Product Change Notification

PCN#21-17 Add process holes on RB series detect switches

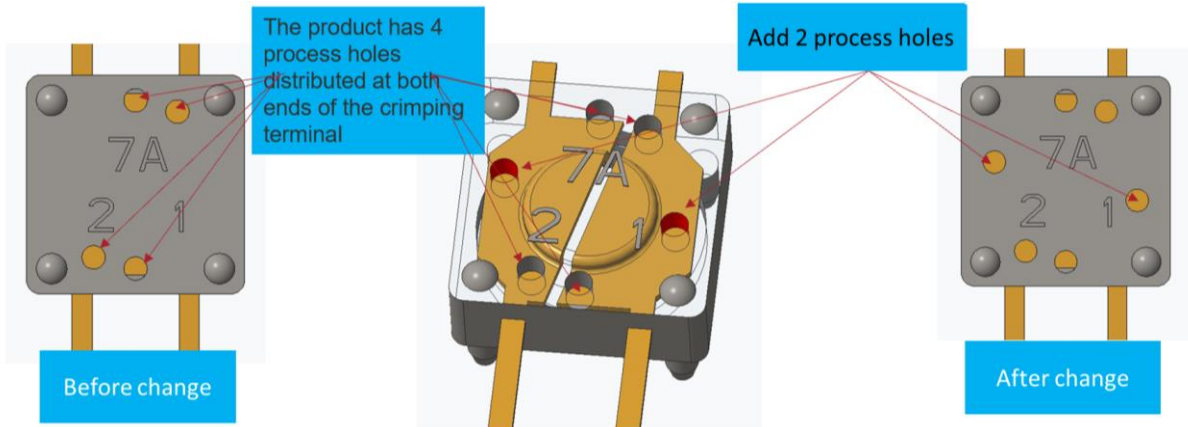
Add process holes on RB series detect switches to improve the injection molding.

Add 2 process holes to improve the injection molding :

Add 2 process holes only, no functional change to this product.
